To: Alan Schutz, Geophysical Survey Systems Inc
From: Andy Leimer
aleimer@fcc.gov
FCC Application Processing Branch

Re: FCC ID QF75106
Applicant: Geophysical Survey Systems, Inc.
Correspondence Reference Number: 23481
731 Confirmation Number: EA740530

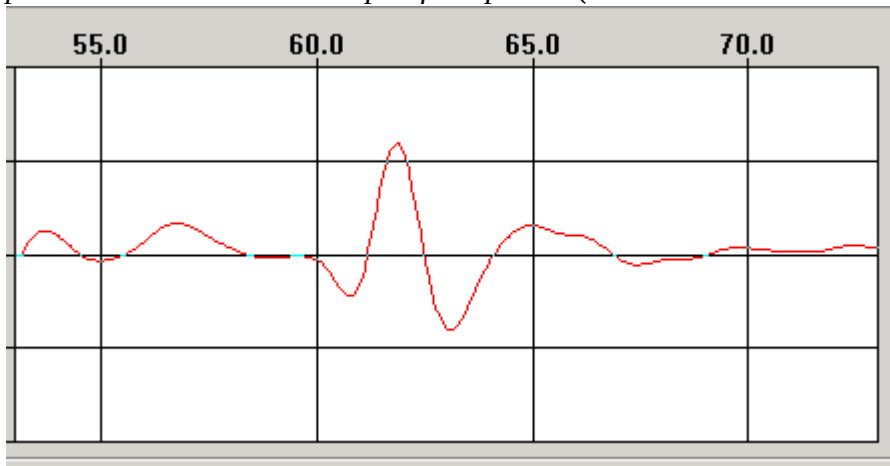
1) More information is needed on the 0.5 ns pulse. Is the pulse pseudo random (dithered) or is it periodic (You mentioned a maximum PRF of 100 kHz). Upload a plot of the pulse.

The pulse is not dithered, it is a fixed frequency. 100 KHz is the maximum allowable PRF because that is the frequency at which the emissions test was performed. The picture below shows the shape of the pulse. (The horizontal scale is in ns.)

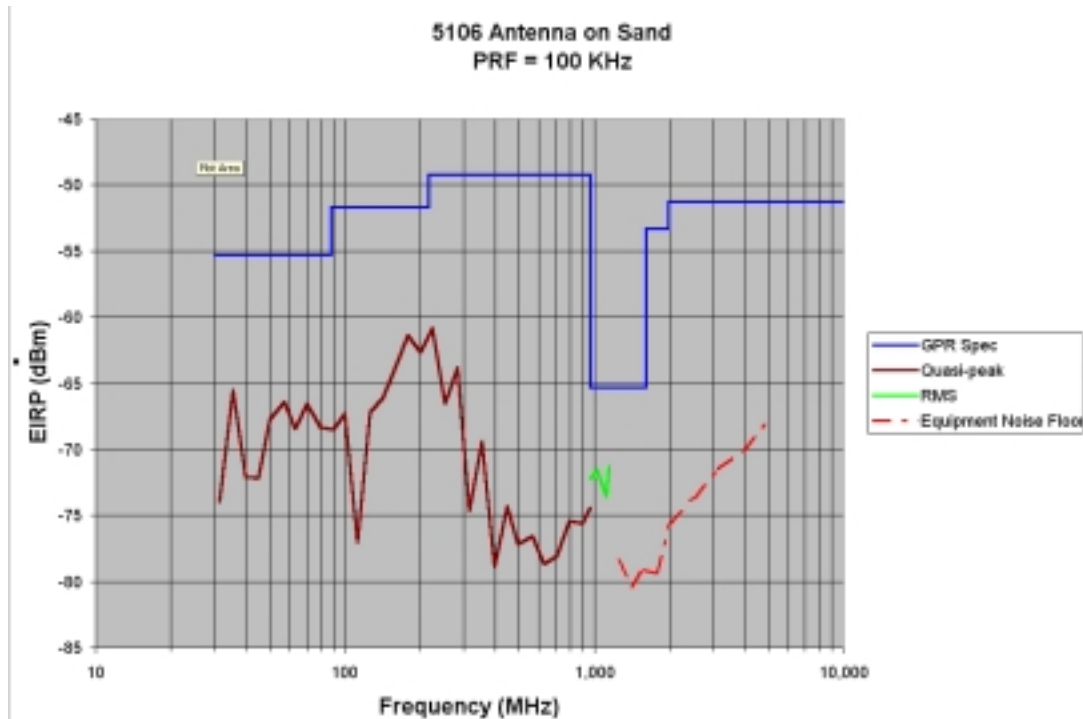
4) There is a procedure in the test report for the -10 dB points but no data or plots. Upload a spectrum plot and data for the -10 dB points. I suggest a field strength measurement for these points to account for non-linearities across the band that would be on the spectrum plot (ie: antenna and amplifier is not equal across the band).

From the plot below, the peak is at 224 MHz. The lower -10 dB point is 112 MHz. The upper -10 dB point is 316 MHz. All data has already been corrected for antenna, amplifier, cables, etc. The data tables are in the test report.
